ADDENDUM TO THE INDIVIDUAL EXPERT REPORT OF DR STEVE PERRENS

Materials Recycling Facility, Moorebank

***Addendum to Expert Report:
Sewage Management, Flooding and Stormwater***

16 September 2016

Figure A1: Indicative Regraded Landform

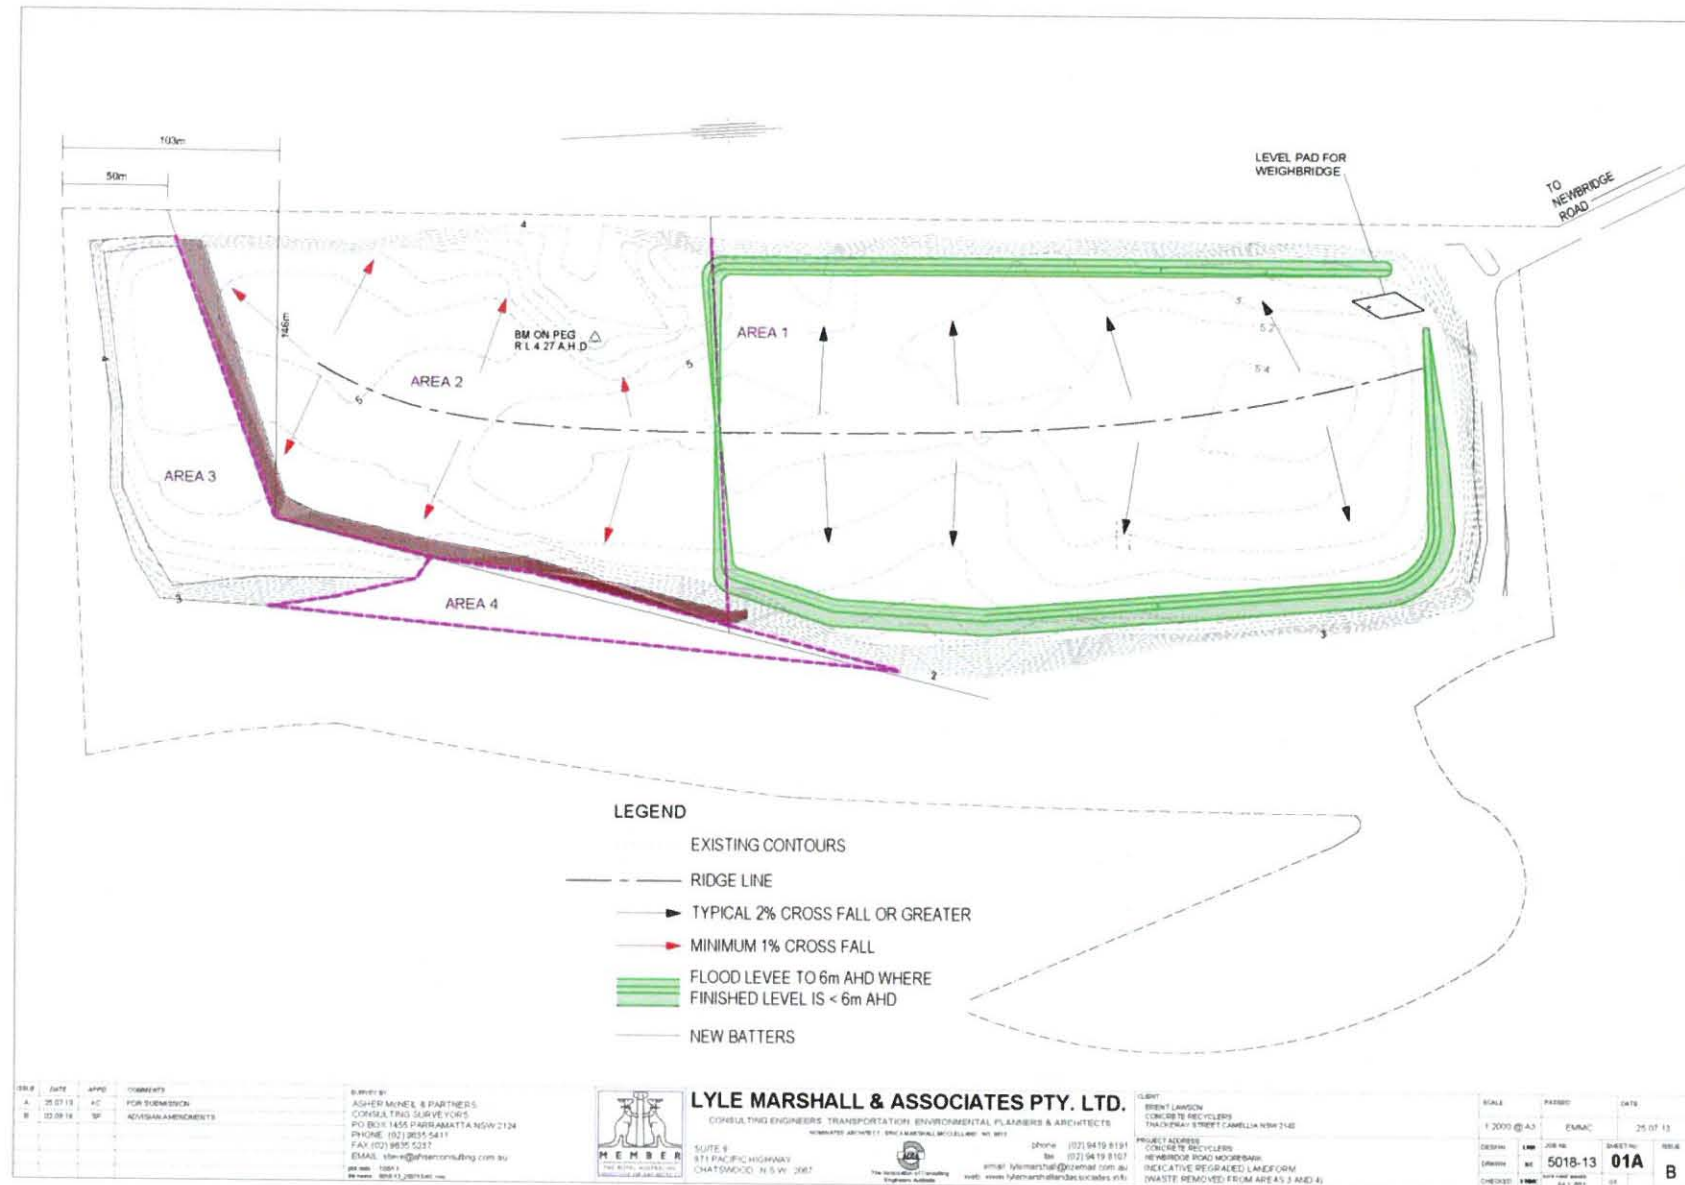
- 31 Figure A1 (next page) shows the indicative regraded landform following the completion of the implementation of the actions proposed under the *Remediation Action Plan* and reconstruction of the landfill cap in accordance with the principles set out in Paragraphs 29 and 30 above. This figure supersedes Figure 1 in my earlier report.

Figure A2: Indicative Arrangement for the Southern Stormwater Sump and Flood Levee Adjacent to the Eastern Leachate Bund

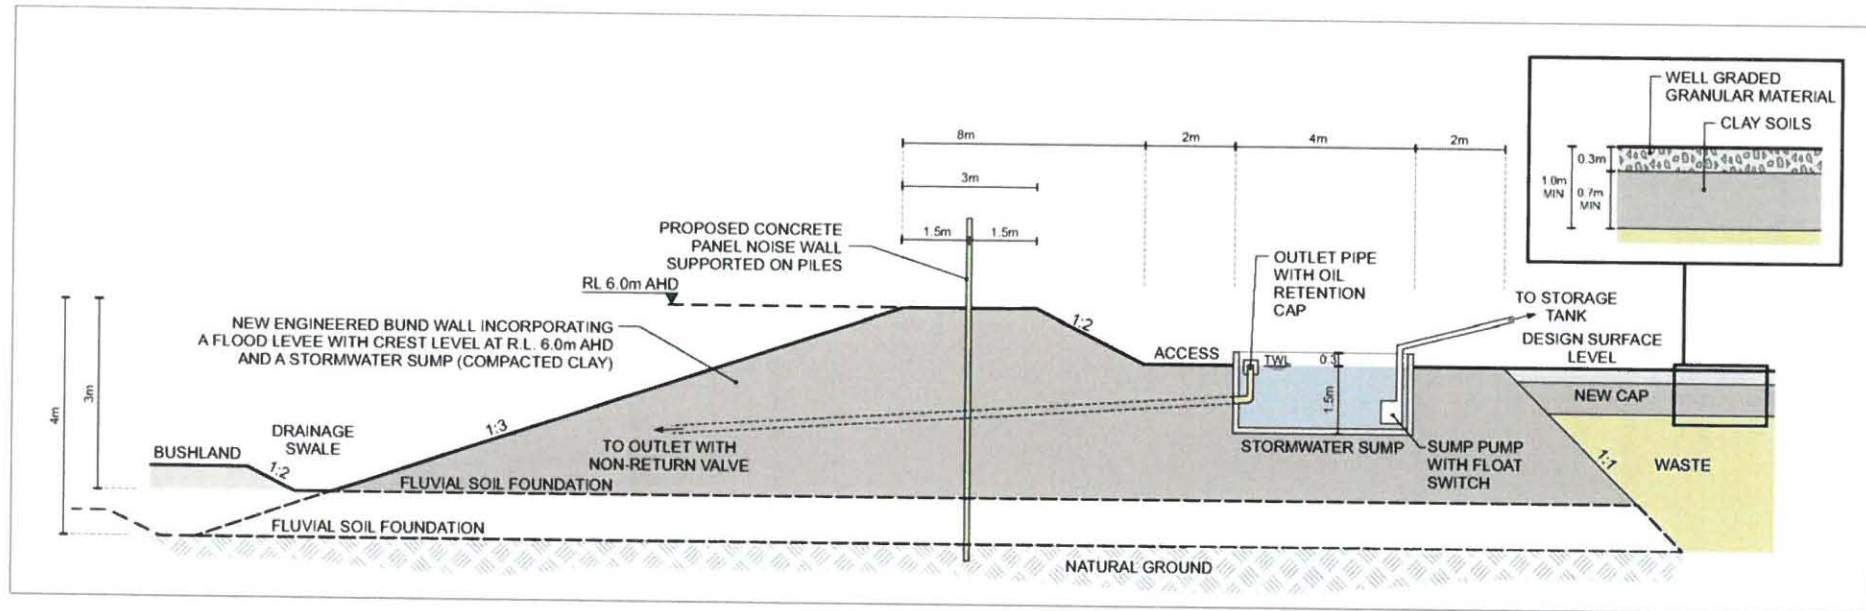
- 32 Figure A2 is an updated version of Figure 4 in my earlier report. This figure reflects further geotechnical advice.
